<b>APPLICATION NUMBER:</b>	PLN-26-028
<b>PROPOSED DEVELOPMENT:</b>	Addition to existing multiple dwelling
<b>LOCATION:</b>	8A Chestnut Avenue Lutana
<b>APPLICANT:</b>	G O'Halloran
<b>ADVERTISING START DATE:</b>	18/04/2026
<b>ADVERTISING EXPIRY DATE:</b>	02/05/2026

**PLANNING APPLICATION – 8A CHESTNUT AVE, LUTANA**  
**DWELLING ALTERATIONS AND ADDITIONS; APPLICATION NO: PLN-26-028**

Further to your request for additional information regarding this application, we provide the following responses and the revised drawings Ap01.A to Ap05.A attached:

**DECEMBER 21 - 3pm**

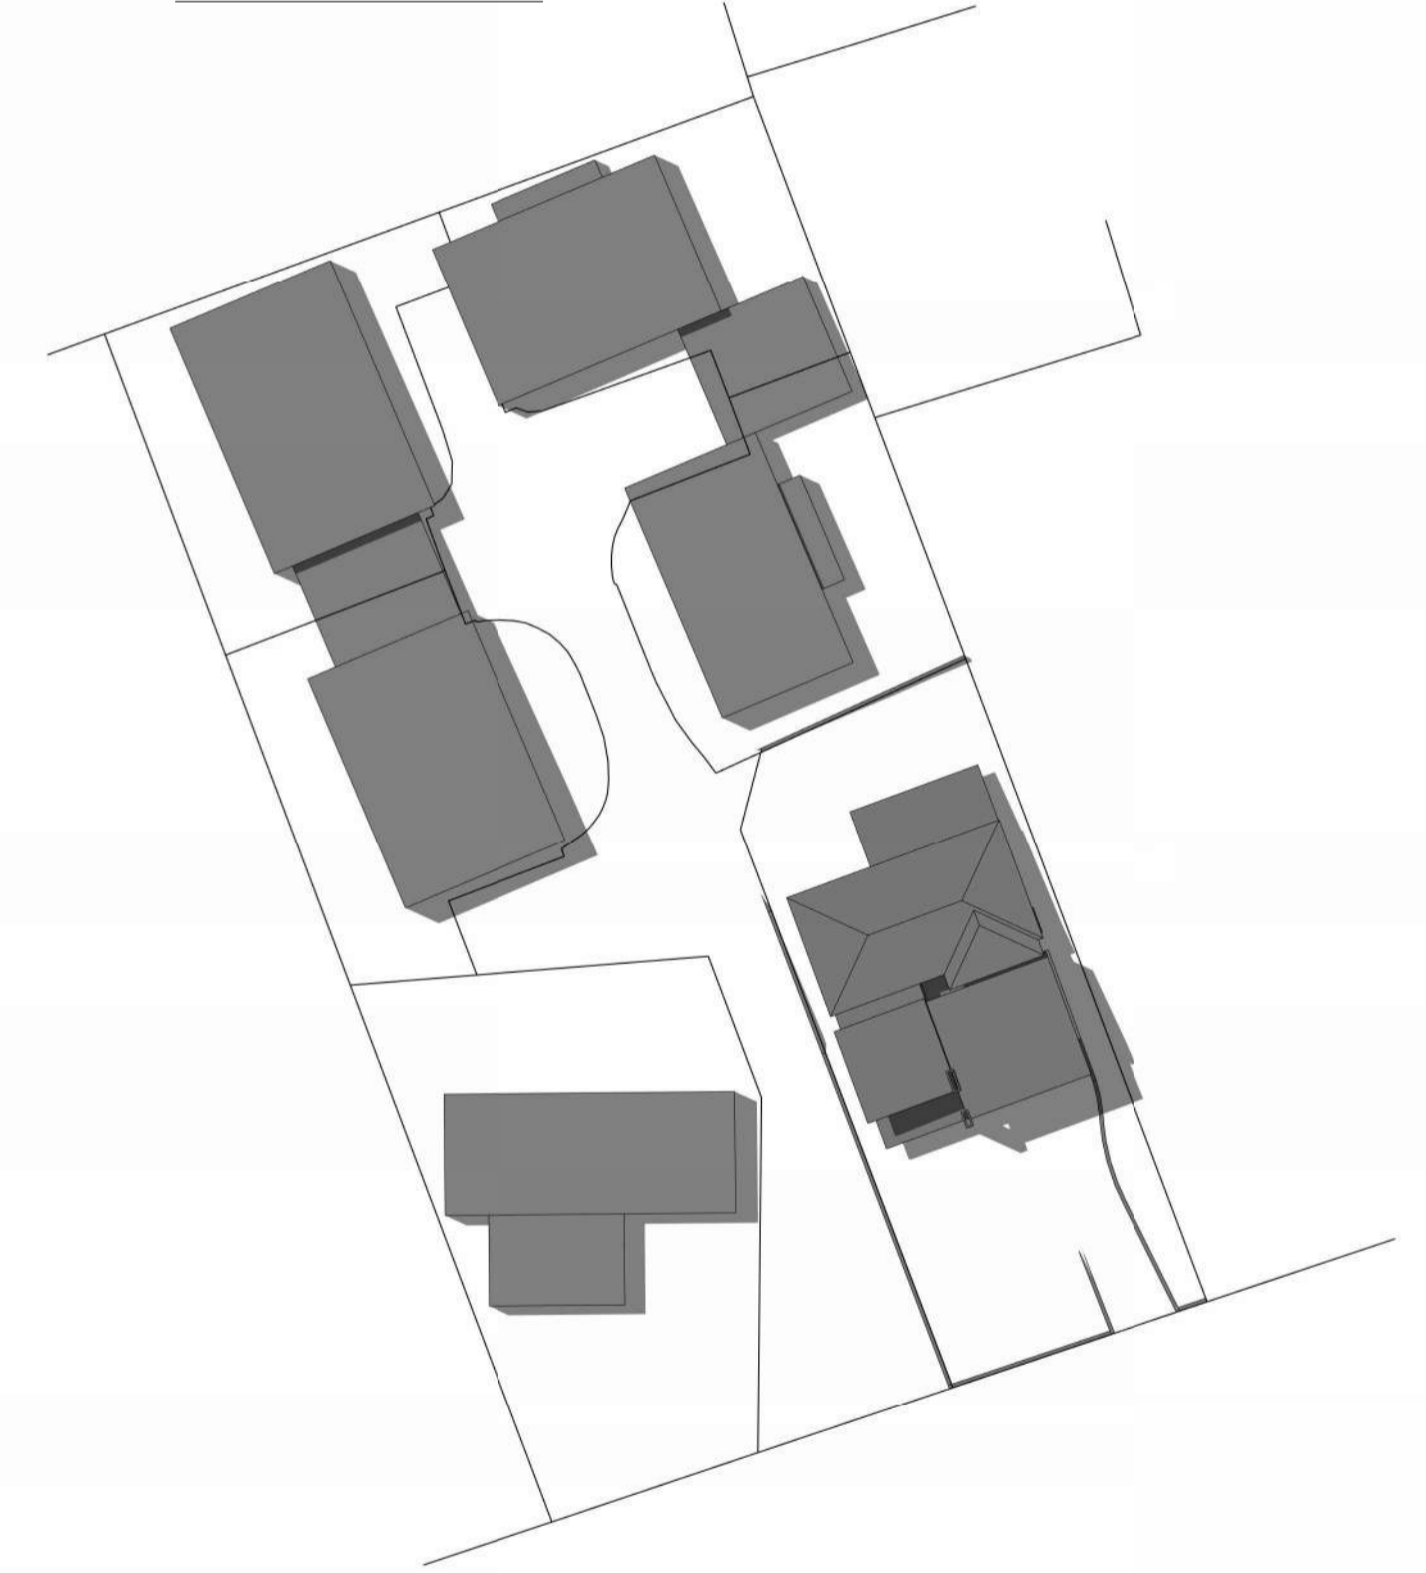
*Please fully address visual impact from the view of the adjacent property at 10 Chestnut Avenue with respect to bulk and scale. Whilst it is appreciated that the proposed height might not be out of place within the general area, the proposal is not in accordance with the minimum setback. The acceptable solution allows a height of 4.5m at the 1.5m setback mark. The acceptable solution requires a minimum setback of 1.5m, unless the building is less than 9m in total length. The total length within the minimum setback margin of the east elevation is more than 16m. This does also not appear consistent with that of existing in the area. Most dwellings in the area, except for outbuildings and small sections, appear to have a minimum side setback of 1.5m.*

Refer to drawing Ap100 Shadow Diagrams for evidence that overshadowing will be negligible in mid-summer and not relevant at all for most of the year.
